# Amendments to the Power System Model Guidelines

Draft Report – Standard consultation  
for the National Electricity Market

**Published: 14 April 2023**

**Figure 1 B4.82 wrapper implementation**

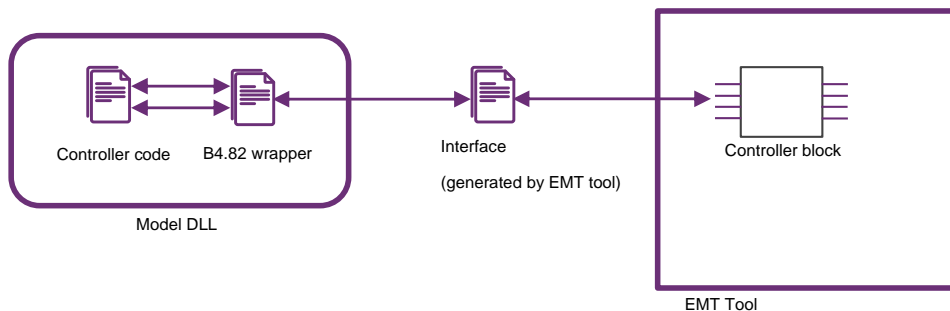
AEMO agrees with several submissions that pointed out that developing a custom interface from scratch for OEMs to adhere to would add unnecessary complication for both AEMO and OEMs, especially given that the Joint Working Group (JWG) B4.82/IEEE wrapper aims to standardise the requirements for DLL provision (all inputs, outputs and parameters, and simulation time step). Many manufacturers have already started provisioning models compliant with the B4.82 wrapper. AEMO believes that the B4.82 interface will address most concerns raised about the structure of the DLL and interface.

The B4.82 wrapper implementation is summarised in the figure below.

Contained inside the model DLL file is the control code as generated from Matlab/Simulink or otherwise, and B4.82 wrapper code. The wrapper code exposes several standardised functions to external simulation tools and connects them to the relevant functions inside the controller code.
